## UNITED STATES JEPARTMENT OF COMMERCE Patent and Trademark Office

## Office Action Summary

Application No. **08/918,194**

Nathasingh et al.

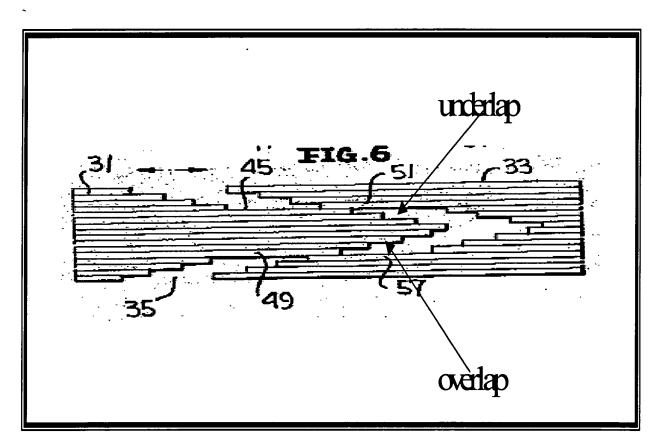
[1] Olsen does not show the overlap/underlap design.

[3] It would have been unlikely that a skilled artisan would use the design of Klappert et al.

Regarding [1]: Examiner shows [see below]

The examiner disagrees.
